Office Action Summary	Application No. 10/582,914	Applicant(s) ITOU ET AL.	
	Examiner Phillip Gray	Art Unit 3767

DETAILED ACTION

Claims 1-21 are rejected under 35 U.S.C. 103(a) as being unpatentable over Cook (U.S. Patent 4,637,396) in view of Fina (U.S. Patent 4,911,163).

Fig. 2

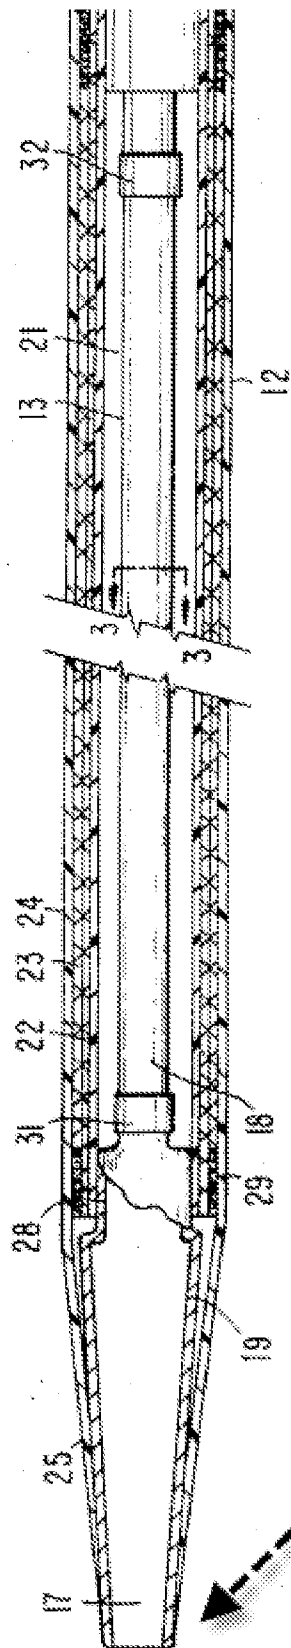
Further see marked up figure 2 of Fina below.

Inner catheter protruding from the
distal end of the outer catheter and
being no more than 10mm

Applicants argue that Cook in view of Fina fails to teach or disclose "...the distance between the distal end of said outer catheter and a distal end of said inner catheter being no more than 10mm". Examiner disagrees. It is examiners position that Fina clearly shows an inner catheter protruding from an outer catheter wherein the distance between both distal ends of the inner and outer catheter is no more than 10mm. Examiner draws applicants attention to fig 2 of Fina (marked up above). Therefor it is Examiners position that Cook in view of Fina (and any obvious modifications thereof) would disclose and teach "the distance between the distal end of the outer catheter and a distal end of the inner catheter being no more than 10mm", as recited in claim 1.
